## DEVELOPMENT APPLICATION ASSESSMENT REPORT

<b>Application Number:</b>	DA2020/0018
<b>Responsible Officer:</b>	Kent Bull
<b>Land to be developed (Address):</b>	Lot 7 DP 242144, 8 Holloway Place CURL CURL NSW 2096
<b>Proposed Development:</b>	Alterations and additions to a dwelling house
<b>Zoning:</b>	Warringah LEP2011 - Land zoned R2 Low Density Residential
<b>Development Permissible:</b>	Yes
<b>Existing Use Rights:</b>	No
<b>Consent Authority:</b>	Northern Beaches Council
<b>Land and Environment Court Action:</b>	No
<b>Owner:</b>	Peter James Walsh Catherine Emma Walsh
<b>Applicant:</b>	Peter James Walsh Catherine Emma Walsh
<b>Application Lodged:</b>	15/01/2020
<b>Integrated Development:</b>	No
<b>Designated Development:</b>	No
<b>State Reporting Category:</b>	Residential - Alterations and additions
<b>Notified:</b>	30/01/2020 to 13/02/2020
<b>Advertised:</b>	Not Advertised
<b>Submissions Received:</b>	2
<b>Clause 4.6 Variation:</b>	Nil
<b>Recommendation:</b>	Approval

**Figure 1.** Drawing No. DA13 by Action Plans depicting the western elevation - Carport/Home Office.

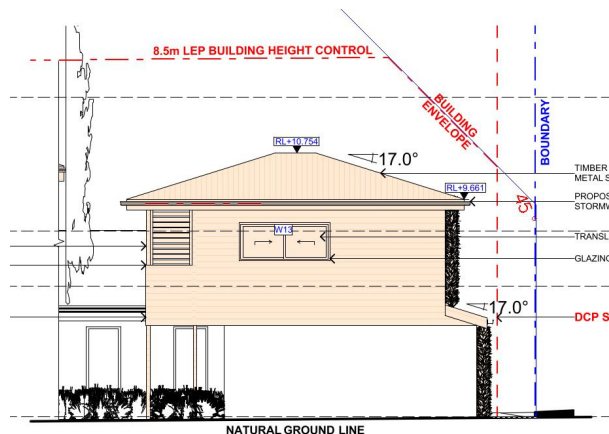
A submission was received from the property owner of No. 23 Bennett Street raising concern and seeking clarification with the proposed southern side boundary envelope in relation to the proposed garage and home office arrangement. The submitted elevation plan (Figure 1) demonstrates a building envelope that has factored in the setback to the southern boundary. The plan should however had indicated a building envelope determined by projecting planes at 45 degrees from a height above ground level (existing) at the side boundaries. As seen in Figure 1, the correct building envelope (marked as a continuous blue line) indicates a 45 degree plane from a measurement of 5m from the southern side boundary demonstrates that proposed development compliant within the building envelope as prescribed under B3 (Side Boundary Envelope) of the Warringah DCP.

- Privacy**  
Comment:  
 A submission was received from the property owner of No. 23 Bennett Street raising concern with overlooking arising from the proposed development, specifically in relation to the western elevation of the home office addition and from the master bedroom balcony. In response to these concerns, the Applicant submitted revised plans on the 31 March 2020 to incorporate a full height privacy screen and changed the window glazing to translucent along the western elevation of the home office. The application has been considered to meet the objectives of Part D8 (Privacy) of the Warringah DCP. See Part D8 (Privacy) of the Warringah DCP for further discussion.

- Building Bulk**  
Comment:  
 Submissions were received from the rear adjoining property owners of No(s) 23 and 25 Bennett Street, raising concerns with southern elevation of the proposed office being a black wall that is designed to have "green wall" installed to soften the visual bulk of the structure. Concerns were also raised with regards to the maintenance and upkeep of this green wall. Consideration has been given that the proposed home office provides an acceptable setback from the southern side boundary and complies with the objectives and requirements of D9 (Building Bulk) of the Warringah DCP that seek to minimise the visual impact of building bulk through such treatments as landscape plantings. Further, the Applicant has agreed to conditions to ensure the establishment and maintenance of this green wall.

The landscaped green wall as indicated in Drawing No. DA13 is to be planted. Evidence demonstrating compliance are to be submitted to the Principal Certifying Authority prior to the issue of the Final Occupation Certificate.
